APPENDIX 4

4A ANSWERS TO QUESTIONS

QUESTION THERMAL SHOCK ON REACTOR VESSEL

SACRAMENTO MUNICIPAL UTILITY DISTRICT

FIGURE 4A.1-1  
 SCHEMATIC OF THERMAL MODEL  
 FOR ECCS OPERATION

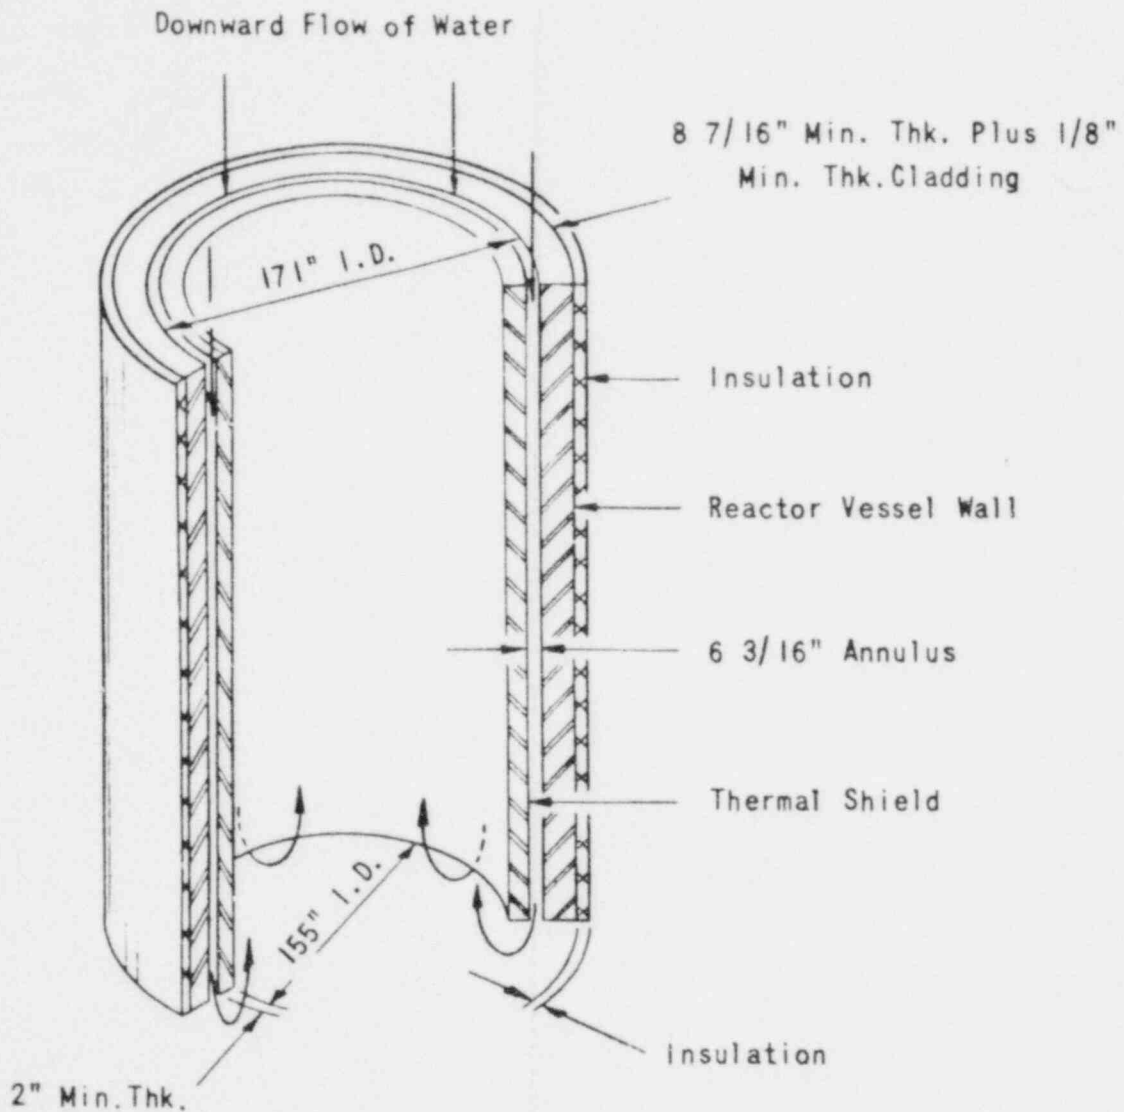
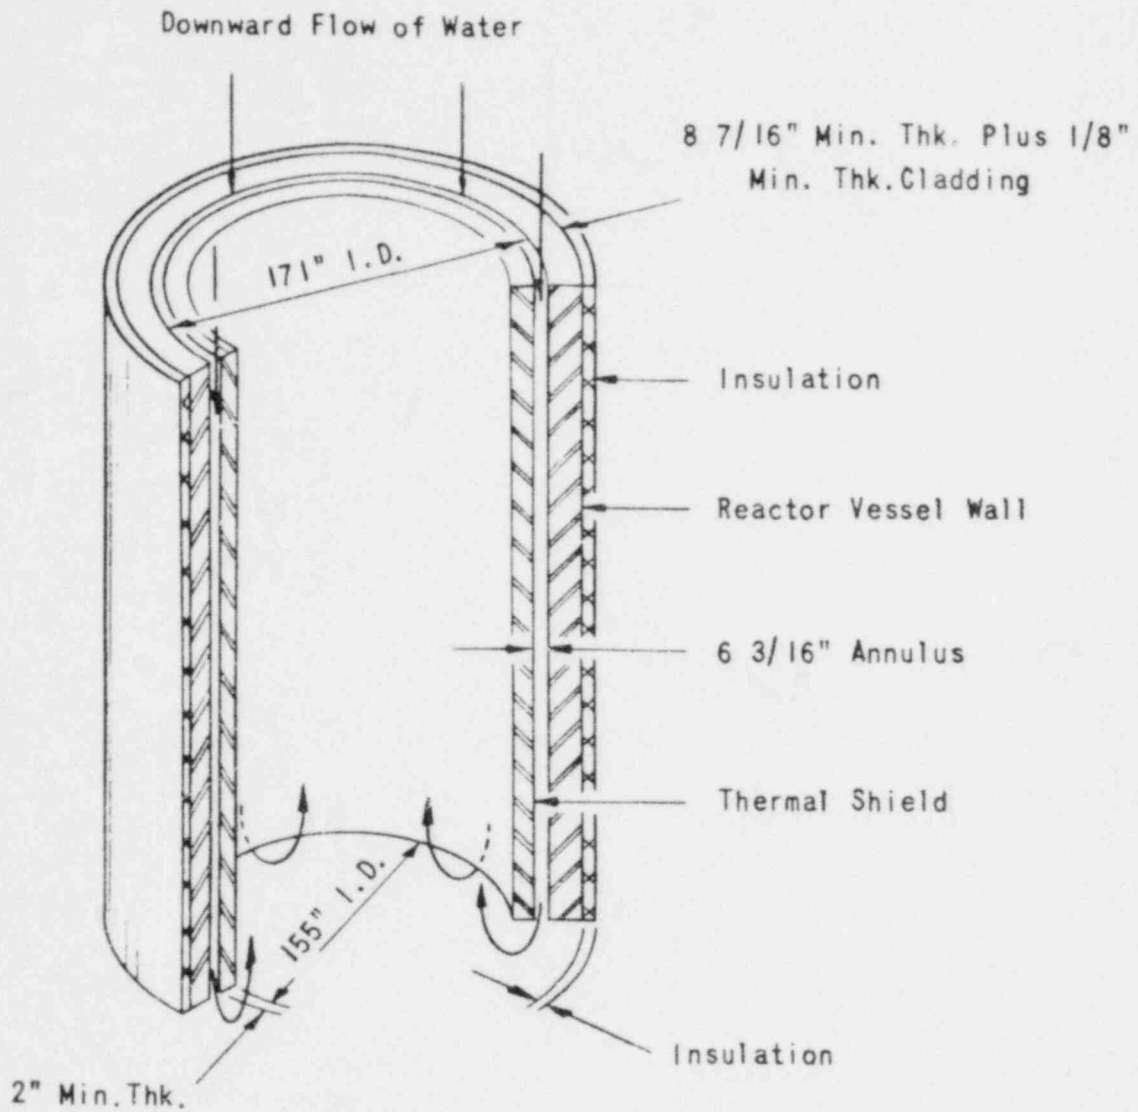
4A.1.1 The geometry of the plate and the cooling method assumed in the analysis,

ANSWER The analysis assumed a long cylindrical section which was insulated on the outside and subjected to a uniform flow of constant temperature (90 F) cold water flowing past the inner wall of the reactor vessel and outer wall of the thermal shield. For general dimensions of the thermal model and flow patch description, refer to Figure 4A.1-1.

FIGURE 4A.1-2  
EFFECT OF VARYING WATER FILM  
HEAT TRANSFER COEFFICIENT

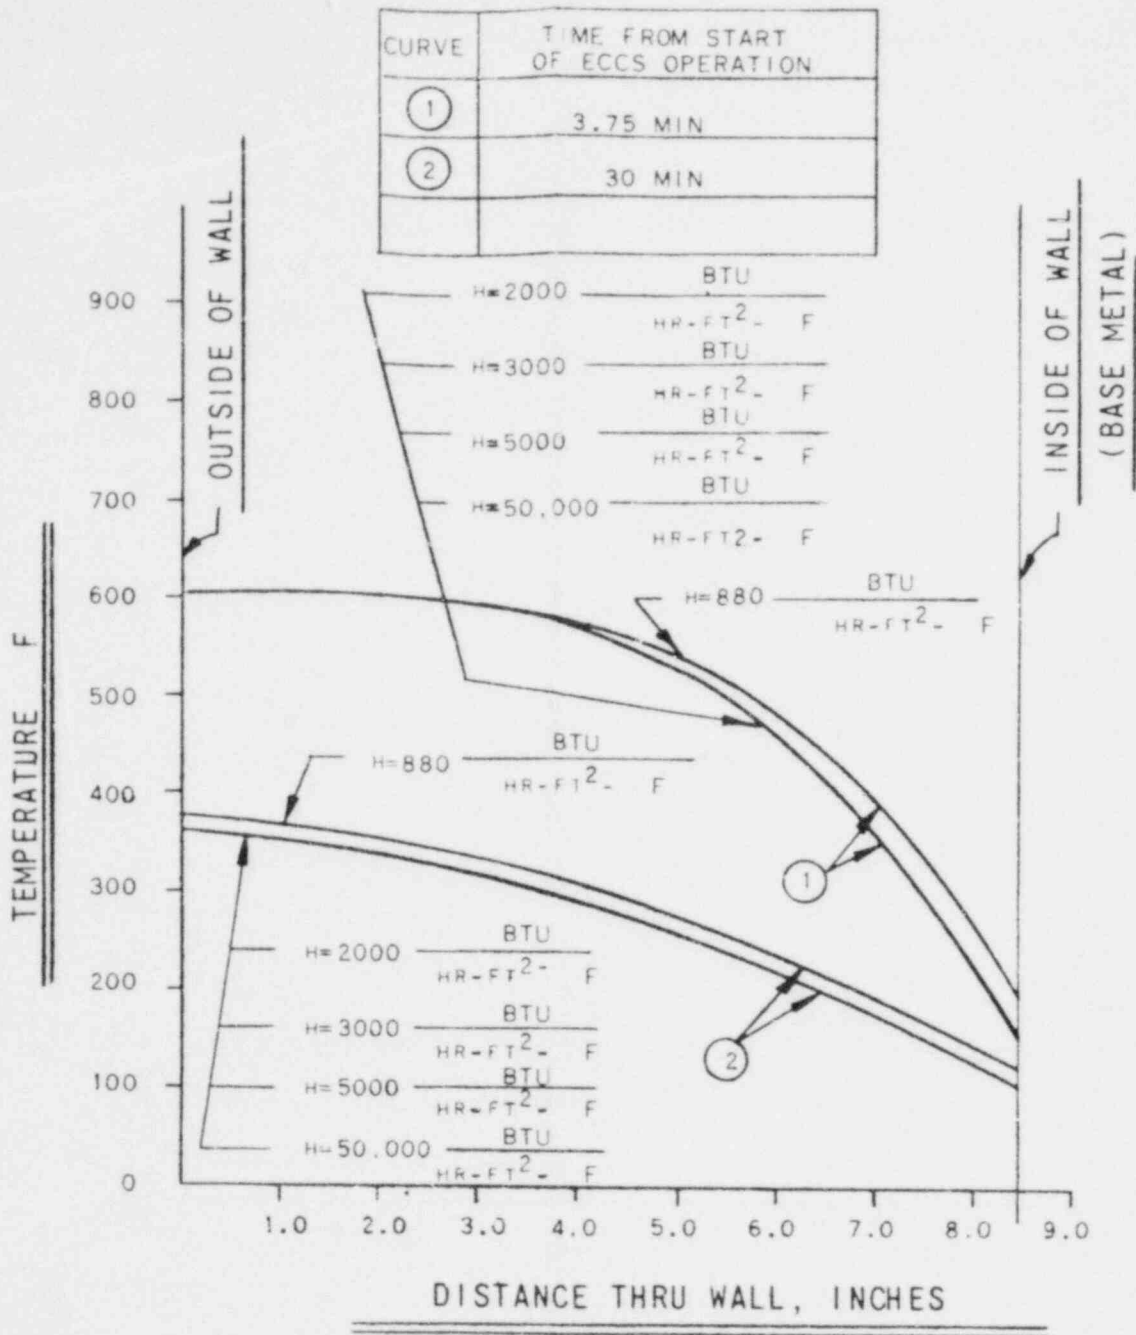
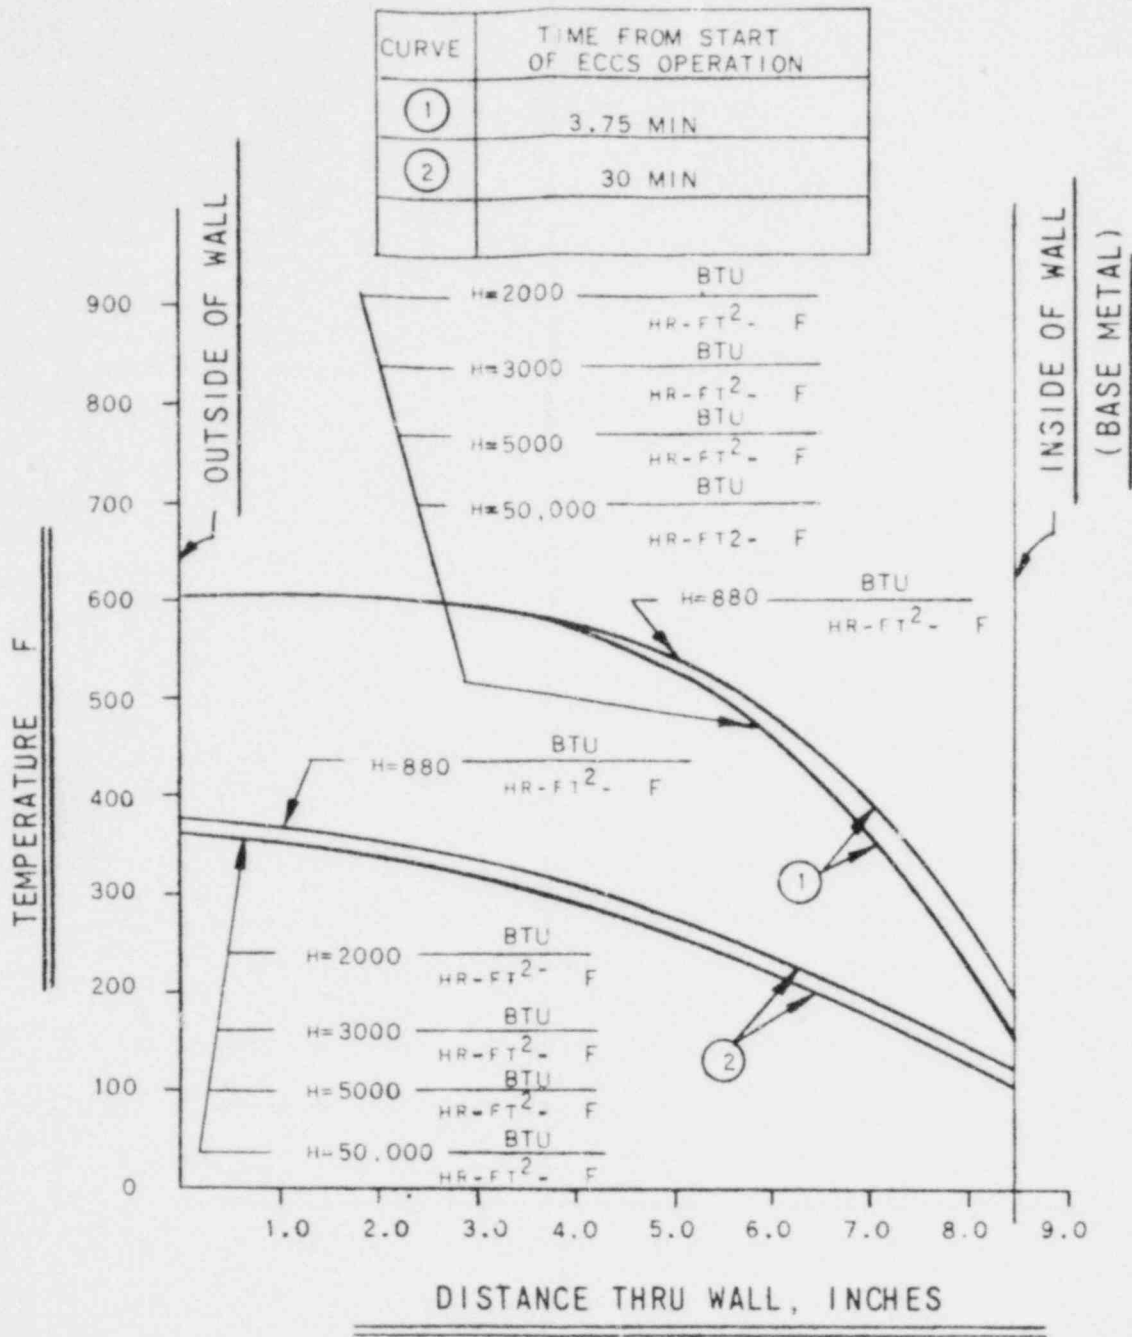
4A.1.2 The heat transfer coefficient used, its experimental basis, and the degree of conservatism involved,

ANSWER The analysis used a water film heat transfer coefficient of 3,000 Btu/hr-ft<sup>2</sup>-F. Using the classical (text book) approach,<sup>5</sup> the water film heat transfer coefficient was calculated to be about 900 Btu/hr-ft<sup>2</sup>-F. However, when the water film heat transfer coefficient reaches a value of 2,000 to 3,000 Btu/hr-ft<sup>2</sup>-F or more, the heat transfer properties of the metal, i.e., the metal conductivity, will govern the heat transfer rate, and consequently the shape and variation of the temperature profile through the thickness of the vessel wall with time (reference Figure 4A.1-2).

FIGURE 4A.1-3  
TEMPERATURE AND MAXIMUM STRESS  
FOLLOWING ECCS OPERATION (409 SEC)

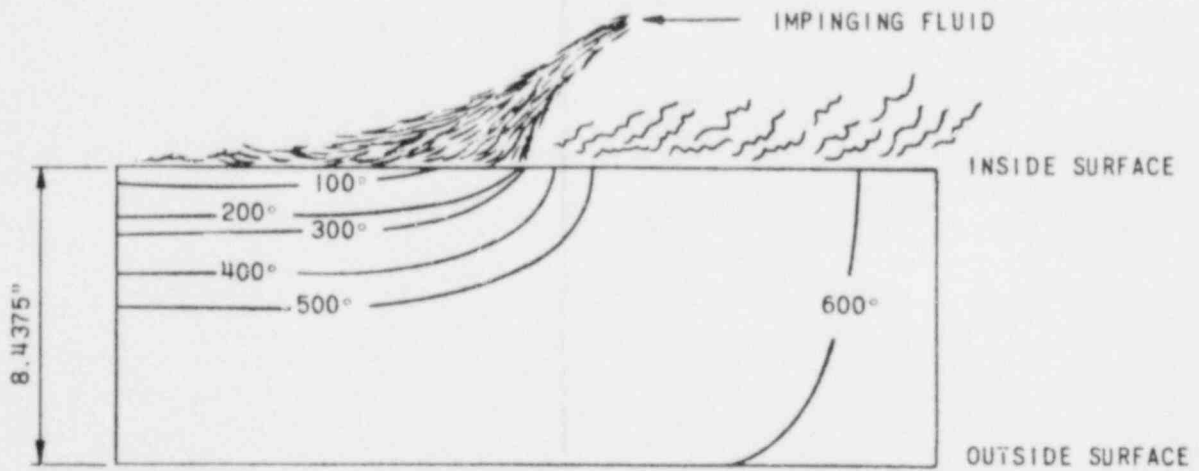
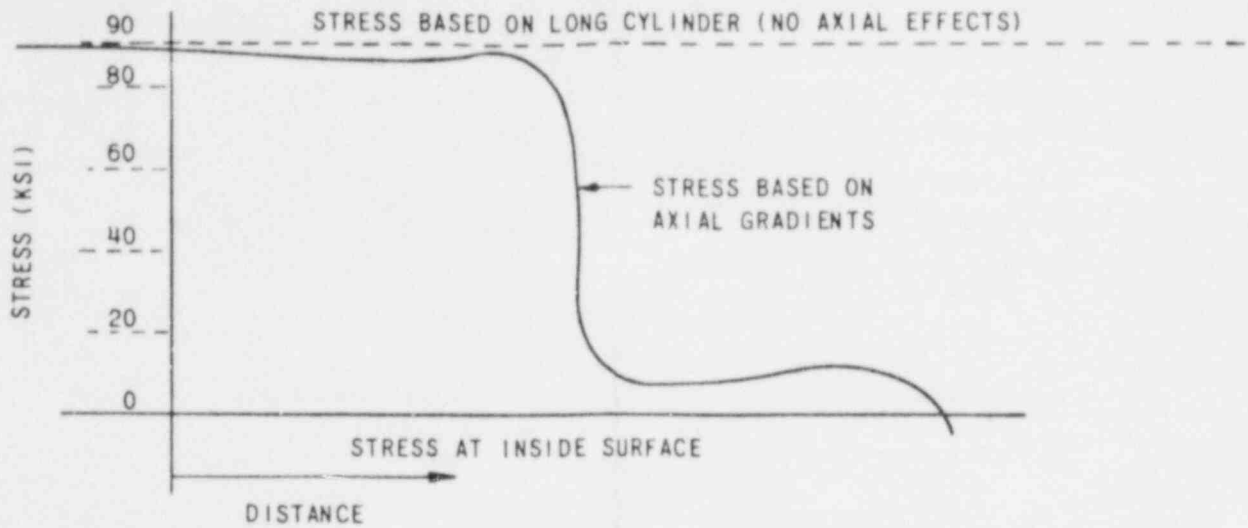
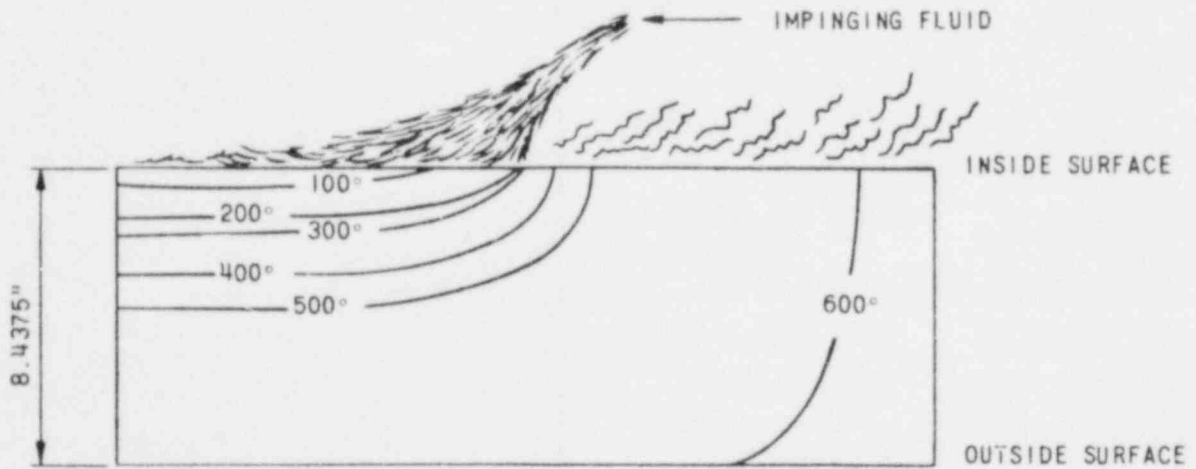
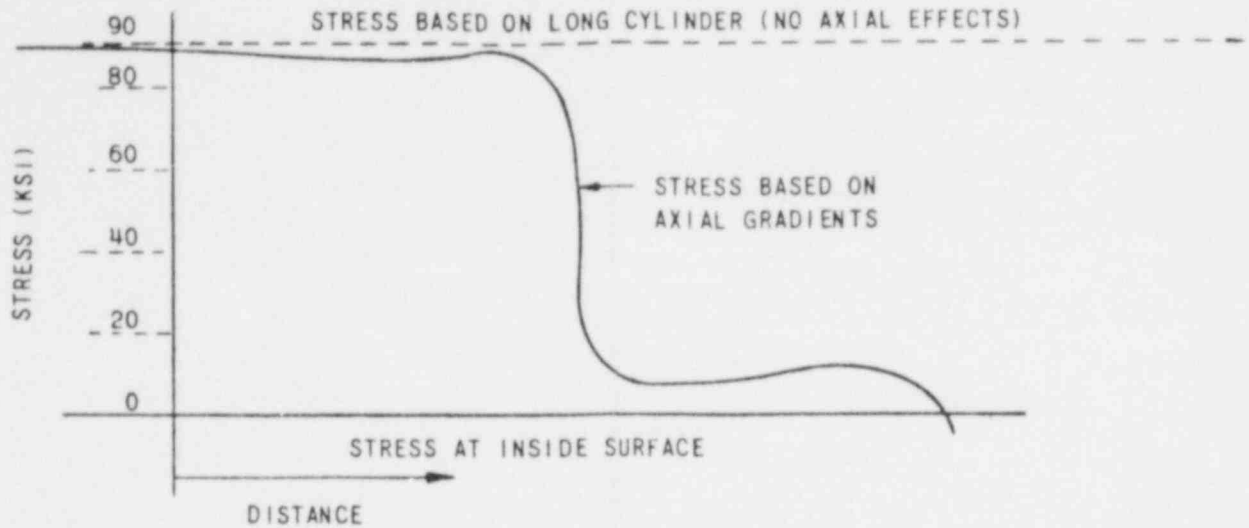
4A.1.4 The effect of axial temperature gradient in the vessel, during filling with cold water, on the total stress intensity,

ANSWER Figure 4A.1-3 shows the temperature profile through the vessel wall when the core flooding water impinges on a section of the vessel wall considering an abrupt line of demarcation between fluid and steam. The use of such an abrupt line of demarcation between fluid and steam is conservative. The conduction of heat through the vessel produces the gradual temperature change as shown on the isotherm plot on Figure 4A.1-3. This temperature distribution has been analyzed using the Seal Shell Computer Program, <sup>9</sup> and the results of this analysis are shown as a stress profile on Figure 4A.1-3. This stress profile shows that the worst stress condition is remote from the line of demarcation between fluid and steam, and that the axial conduction has more than offset any adverse influence of the uncooled portion of the vessel wall. Therefore, the original analysis, assuming a long cylinder subjected to a uniform quench, has presented the worst condition because the effect of the axial gradient will locally decrease the stress produced by ECCS operation in the LOCA.
